HISTORIC AND DESIGN REVIEW COMMISSION

July 15, 2020

HDRC CASE NO: 2020-292
ADDRESS: 801 LABOR ST
LEGAL DESCRIPTION: NCB 733 BLK 5 LOT 8 & N 50 FT OF 7 ARB A8
ZONING: RM-4, H
CITY COUNCIL DIST.: 1
DISTRICT: Lavaca Historic District
APPLICANT: Rudy Macias/LOCKE-MACIAS CHRISTINA ANN & RODOLFO MACIAS
OWNER: Rudy Macias/LOCKE-MACIAS CHRISTINA ANN & RODOLFO MACIAS
TYPE OF WORK: Front yard fence installation
APPLICATION RECEIVED: June 23, 2020
60-DAY REVIEW: Not applicable due to City Council Emergency Orders
CASE MANAGER: Rachel Rettaliata
REQUEST:

Google Maps 801 Labor St

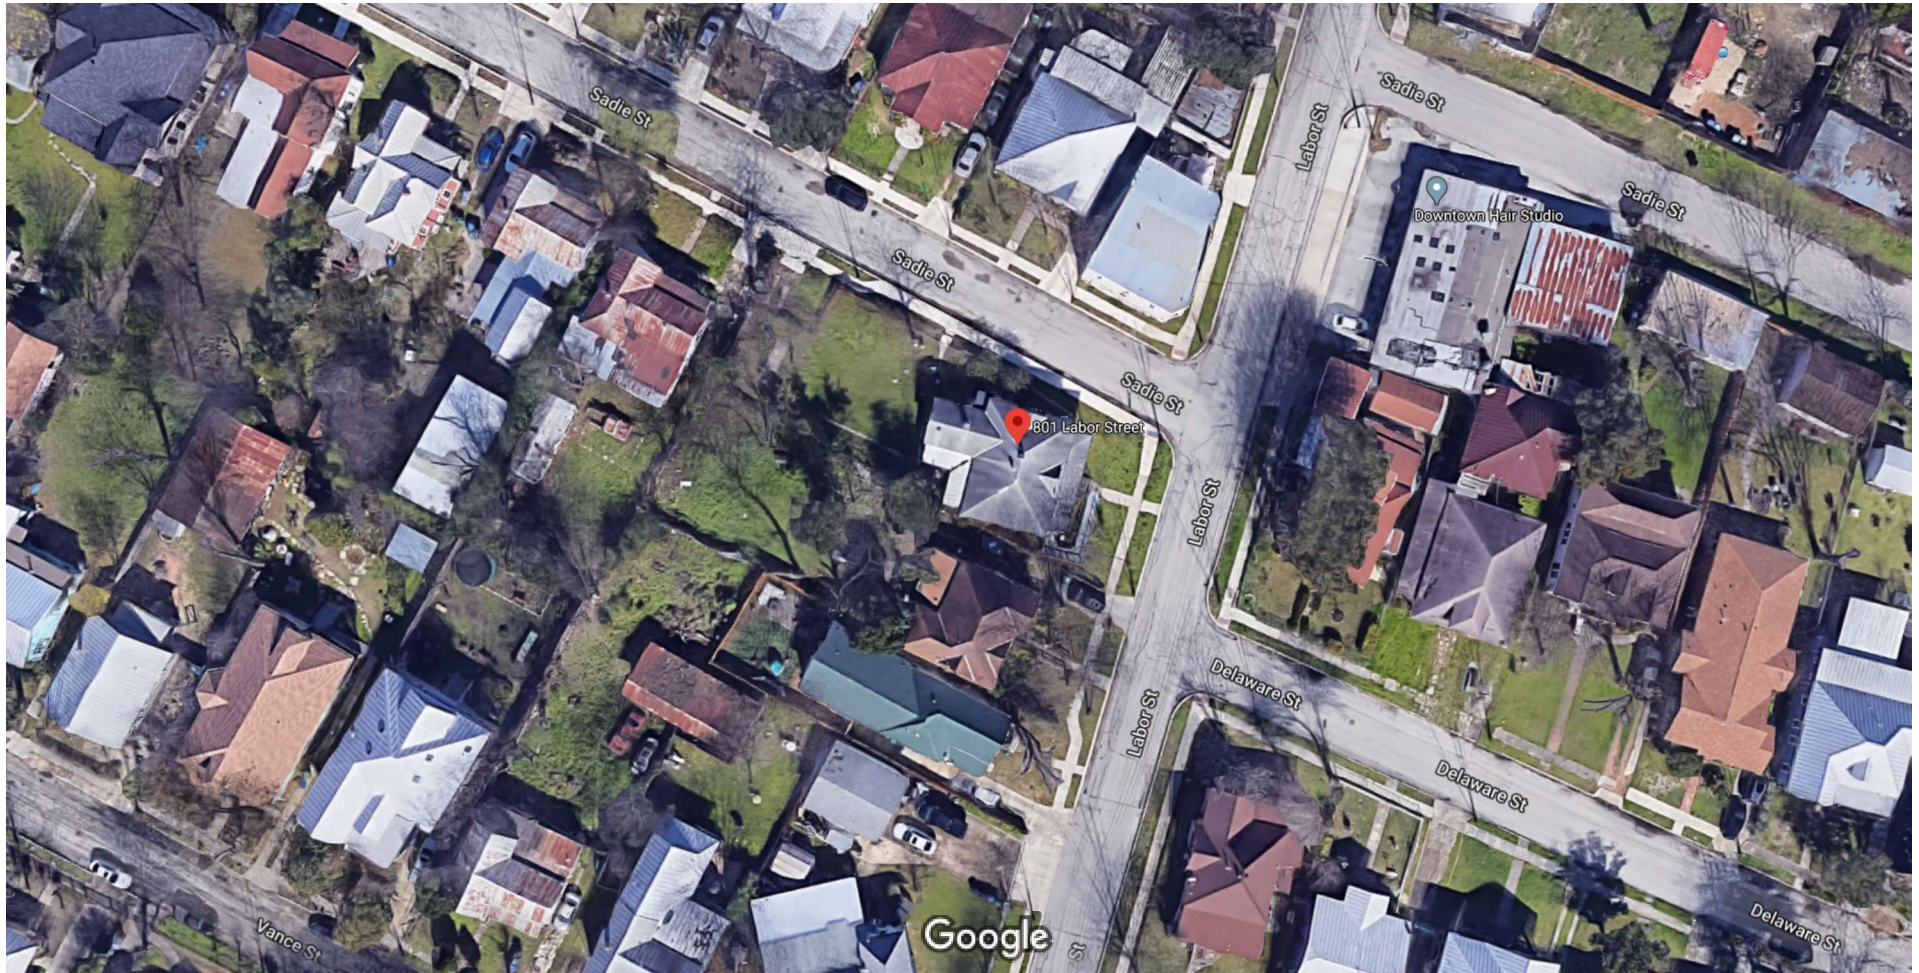
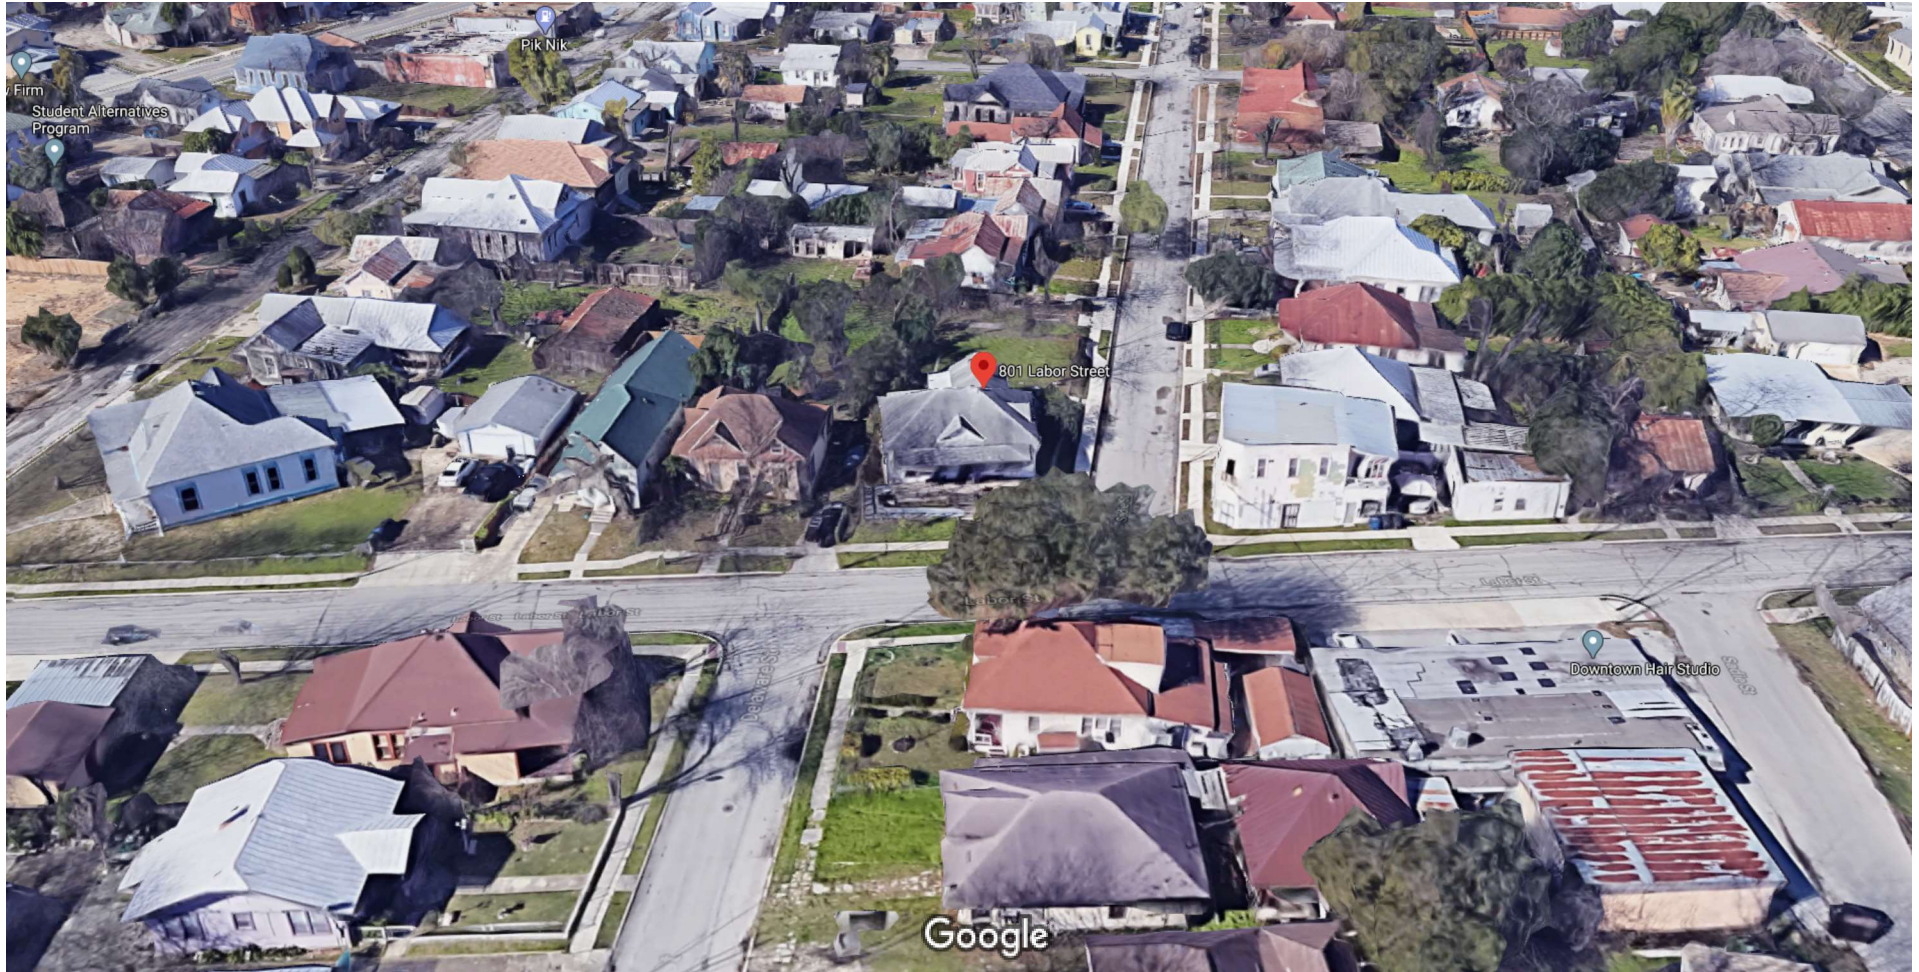
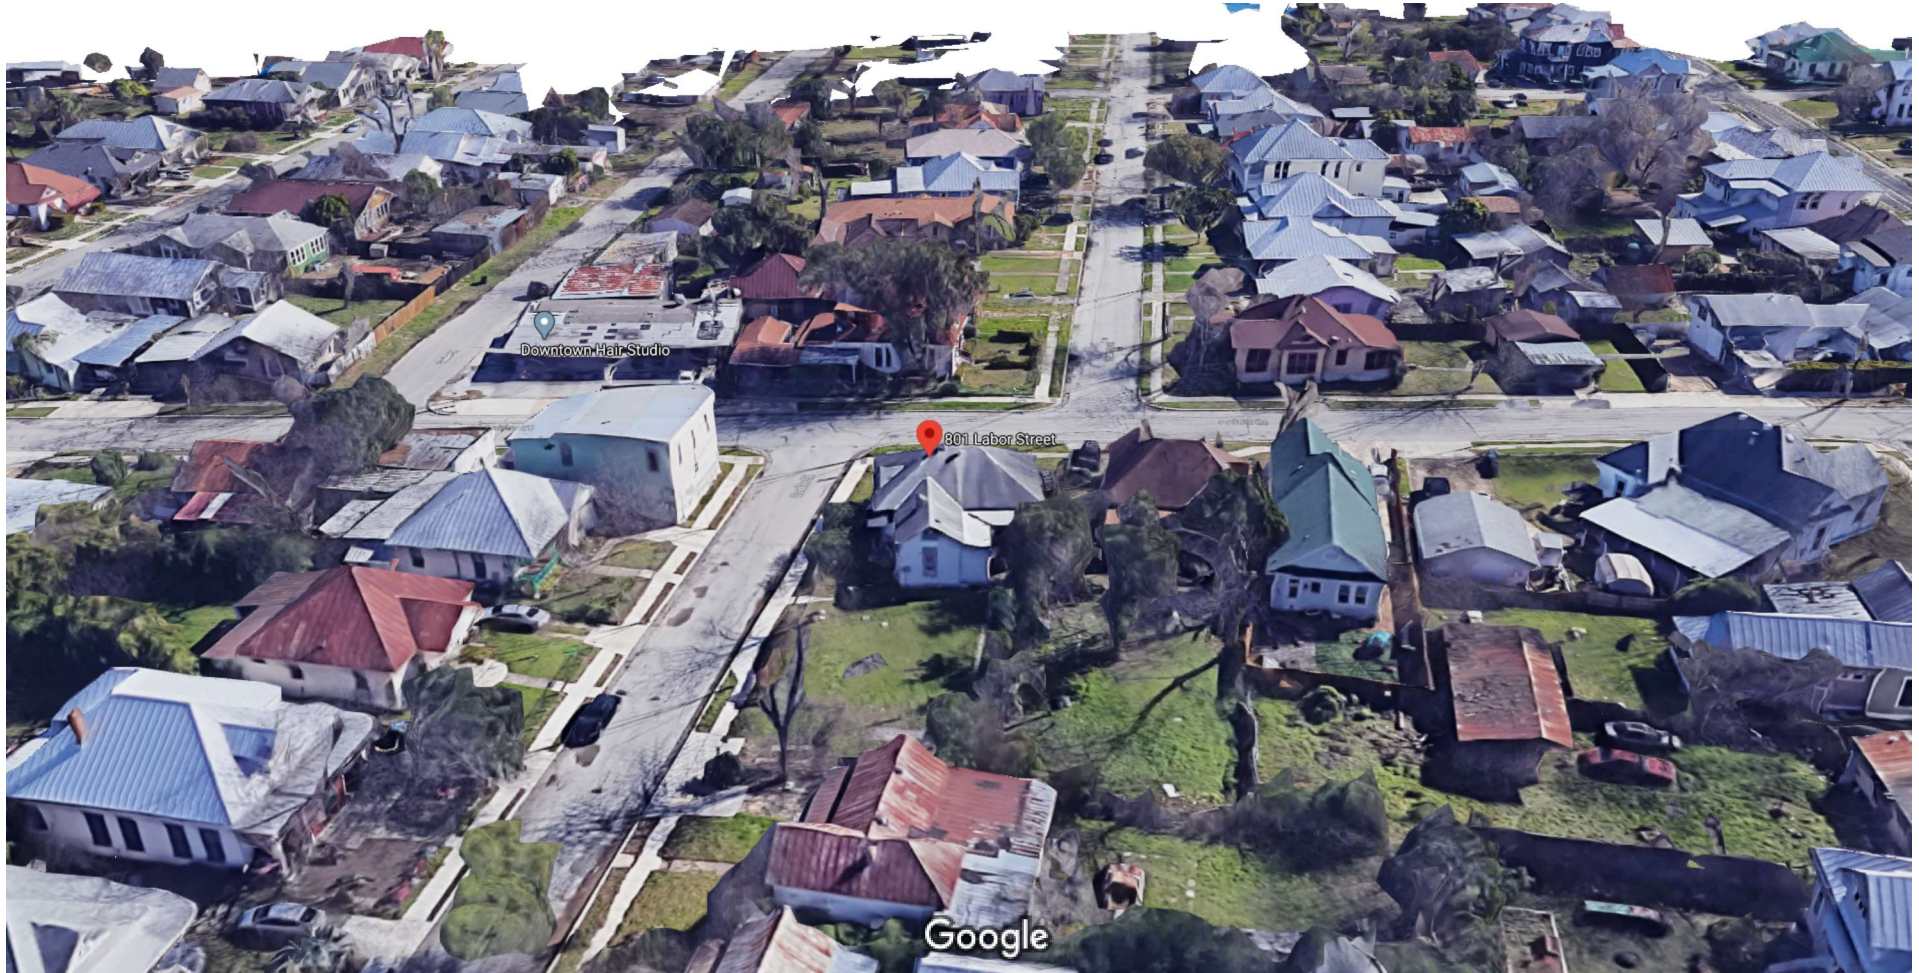
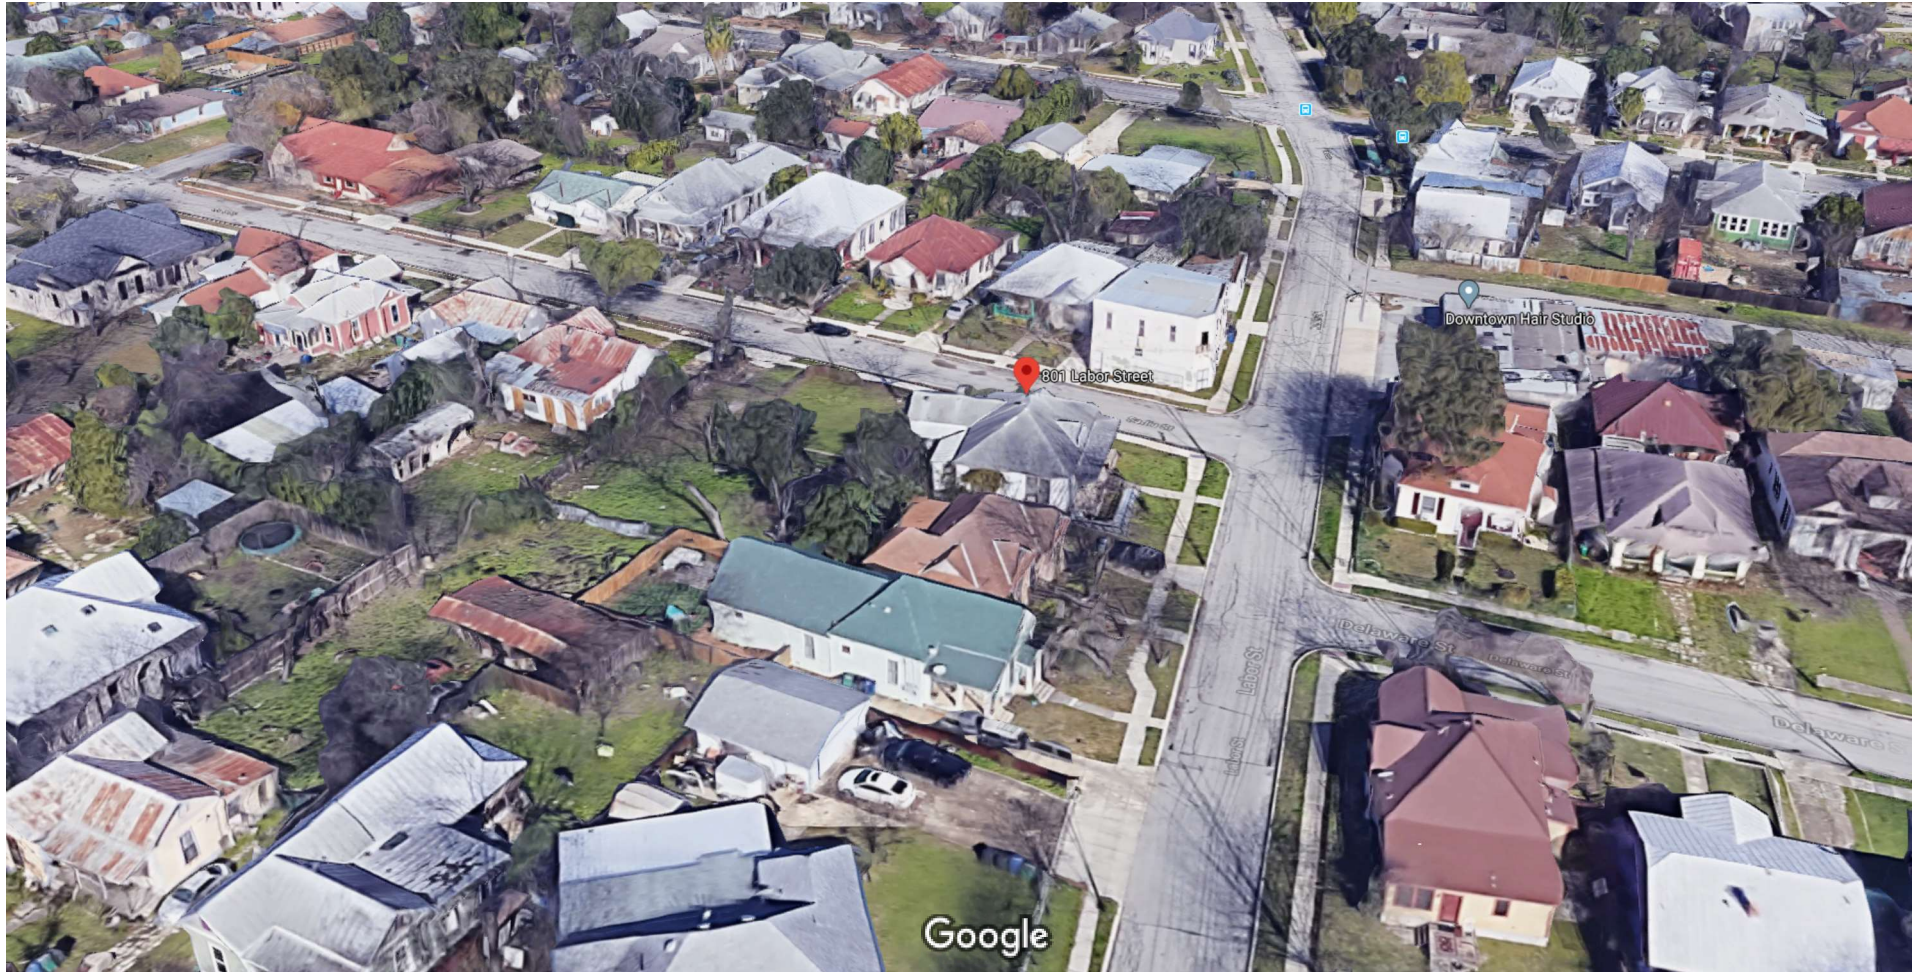
- b. FENCE DESIGN AND HEIGHT – The applicant has proposed to replace the existing chain link fence on the north side of the property with a 4-foot-high iron cattle panel fence and to install a 3-foot-high iron cattle panel fence on the front and south sides of the property. The house is located on a corner lot and the proposed fencing will extend from the neighboring property line on Labor to the existing chain link fence at the rear of the property line on Sadie Street. According to the Historic Design Guidelines, new front yard fences should appear similar to those used historically within the district in terms of their scale, transparency, and character. Staff find that cattle panel fencing is generally appropriate for the district, but finds that the posts and rails should be wood in lieu of the proposed fully metal fence. Fully wood fencing is more consistent with fence materials historically used in the Lavaca Historic District.

- c. FENCE LOCATION – According to the Historic Design Guidelines, new front yard fences should follow historic fence placements in the district. The proposed fence will follow the established fence line along Labor Street and will extend to the rear property line on Sadie Street. The proposed fence will meet an existing chain link fence at the rear property line. Staff finds the proposal consistent with the Guidelines.

Staff recommends approval of the installation of front and side yard fencing based on findings a through c with the following stipulations:

- i. That posts and rails are wood in lieu of the proposed fully metal fence as noted in finding b.
- ii. The final construction height of an approved fence may not exceed the maximum height as approved by the HDRC at any portion of the fence. Additionally, all fences must be permitted and meet the development standards outlined in UDC Section 35-514.

801 Labor St.

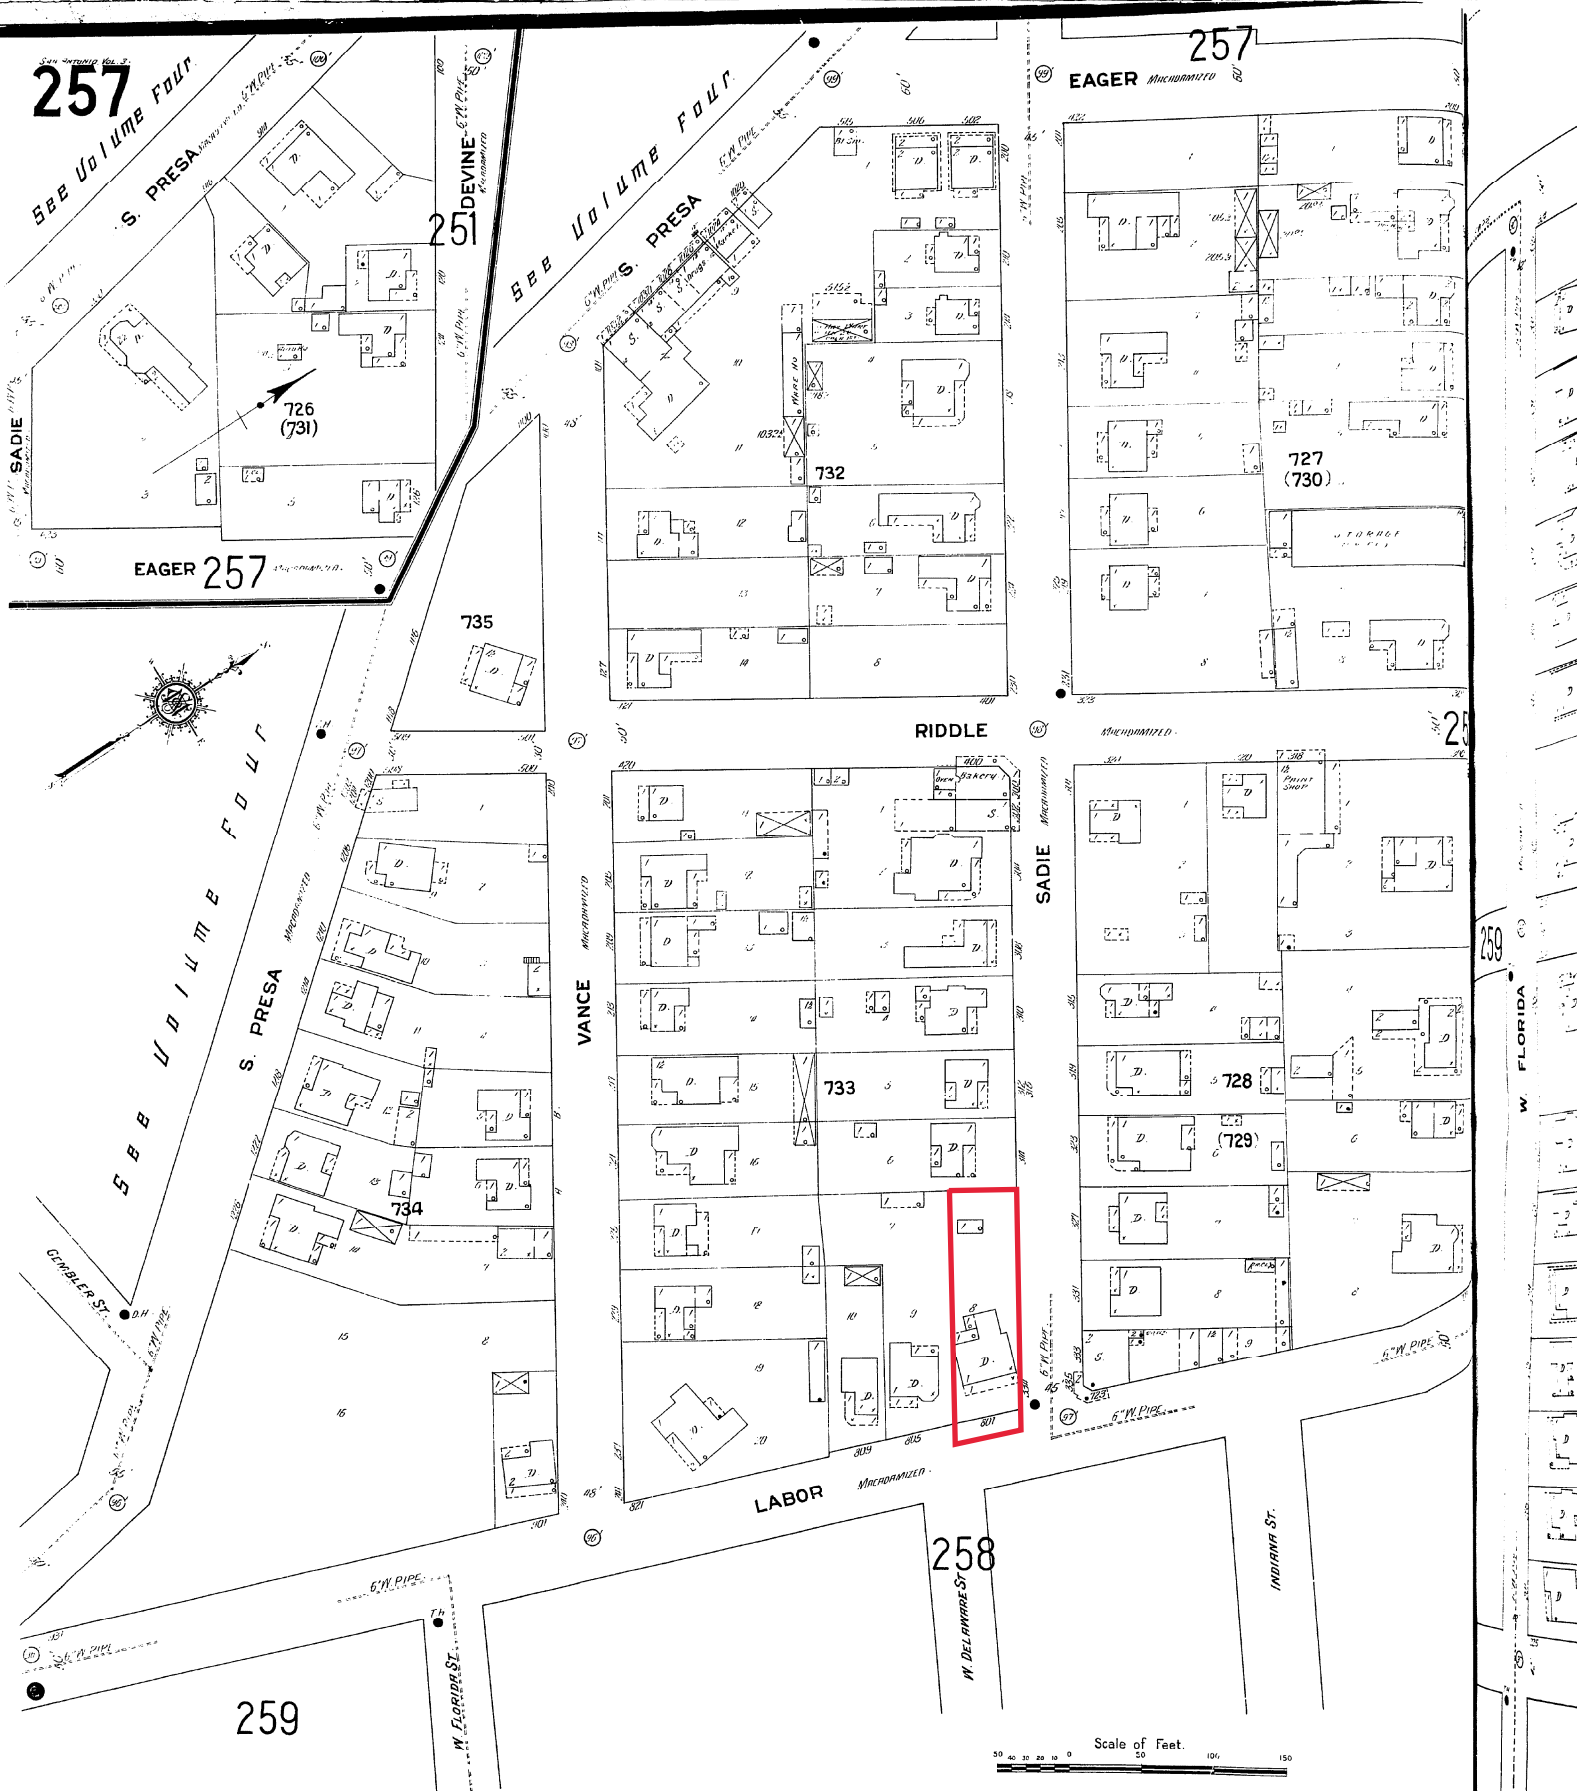
New 3' Fence
